Item Name: Crosstube Turning Detail

DART AEROSPACE LTD	Work Order: 77267
Description: Crosstube Assembly (412 High Aft)	Part Number: D412-664-243
Inspection Dwg: D412-664-243 Rev: E	Page 1 of 1

DRAWING NO. D412-664-243	TITLE CROSSTUBE ASSEMBLY (412 HI AFT)	REV. E	DART AEROSPACE LTD ENGINEERING ORDER		D.E.O. NO. D412-664-243-E-1	SHEET NO. SHEET 1 OF 2	SCALE NTS
DRAWN	CHECKED <i>MP</i>	MFG. APPR. <i>E</i>	APPROVED <i>MP</i>		DE APPR. <i>MP</i>		
DATE 11.03.31	DATE 11/03/31	DATE 11.03.31	DATE 11/03/31		DATE 11.03.31

DRAWING NO. D412-664-243	TITLE CROSSTUBE ASS'Y (412 HI AFT)	REV. E	DART AEROSPACE LTD ENGINEERING ORDER		D.E.O. NO. D412-664-243-E-2	SHEET NO. SHEET 1 OF 1	SCALE NTS
DRAWN 90	CHECKED ASS	MFG. APPR. R	APPROVED MP		DE APPR. H		
DATE 11.09.07	DATE 11.09.19	DATE 11.09.19	DATE 11.09.19		DATE 11.09.19

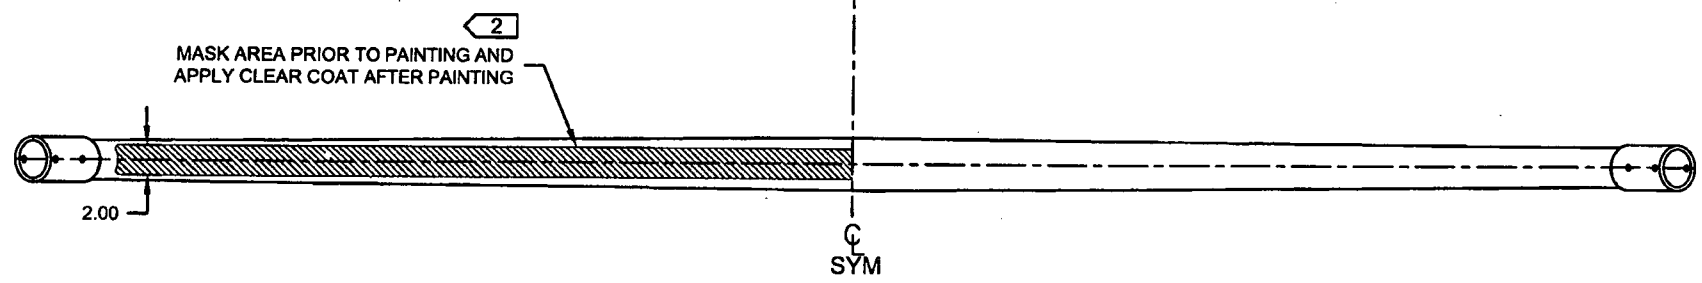
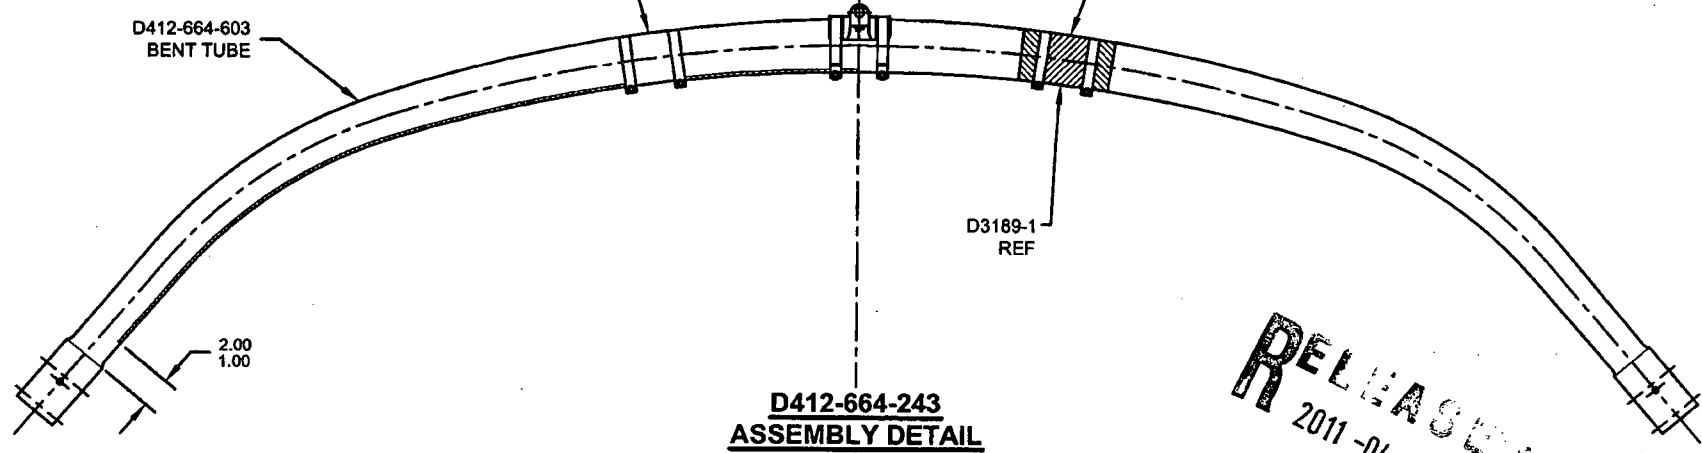
REMOVED ABRASION STRIP IN FAVOR OF A THIN LAYER OF PROSEAL 890.

D3189-1 CHAFING SHIELD (1, INSTALLED OVER PROSEAL 890)
MS21920-28 CLAMP, 2X
2 PL

D2856-600-1009 ABRASION STRIP
D3189-1 CHAFING SHIELD (1, INSTALLED OVER ABRASION STRIP)
MS21920-28 CLAMP, 2X
2 PL
